# *Field Software Notice*

Platform: **2600 Repeater**  
Protocol: **Conventional**  
Version Release #: **2.6.8**  
Supersedes Version#: **1.26.4/2.6.5**  
Effective Release: **June 21, 2007**

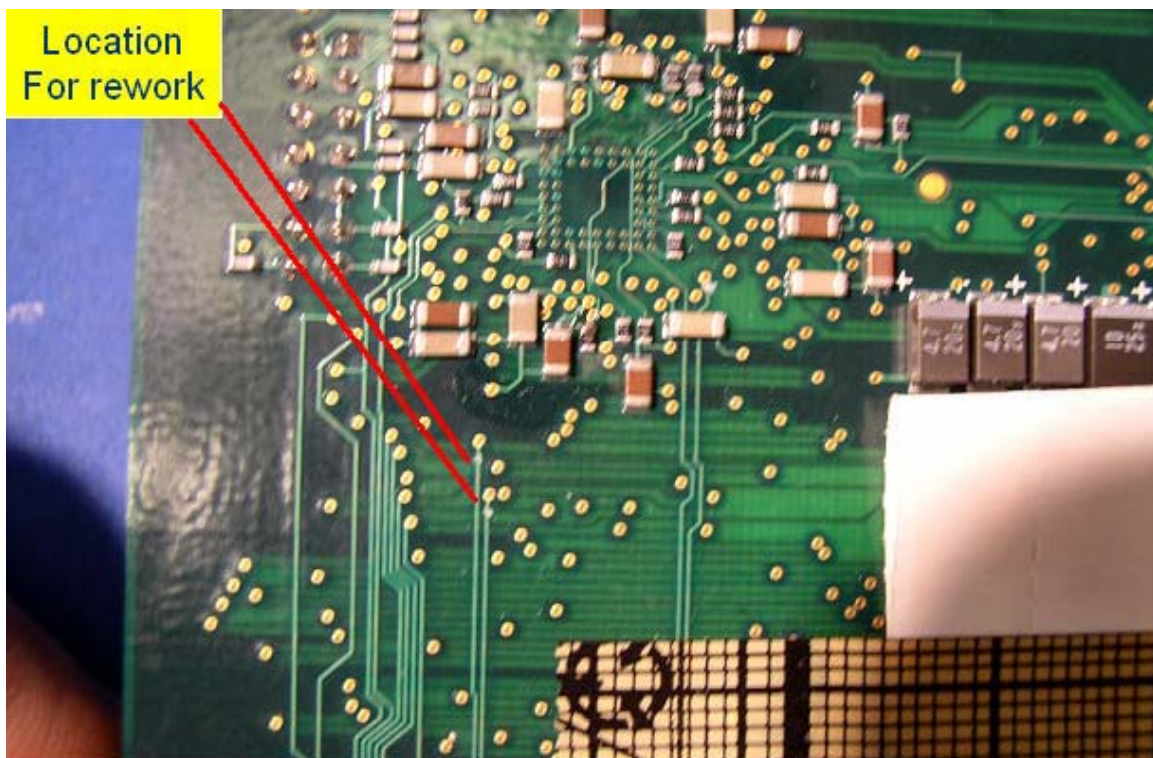
Verify traces are cut.

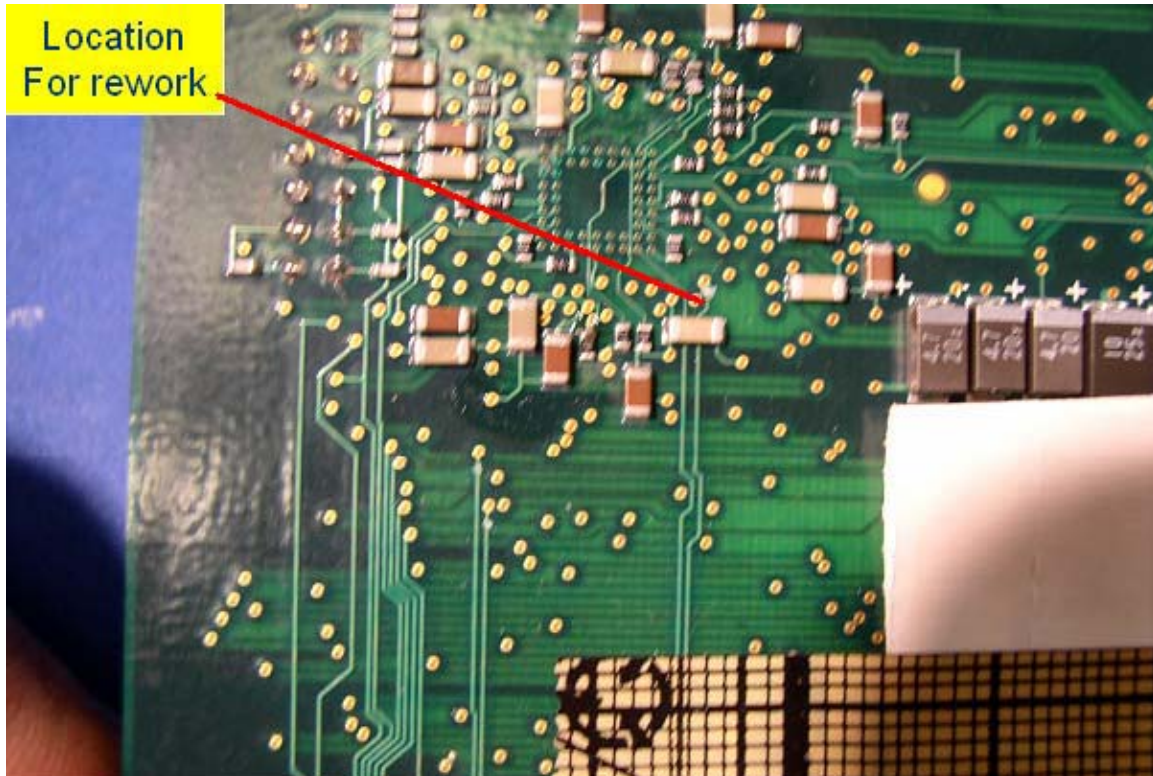
Verify traces are cut.
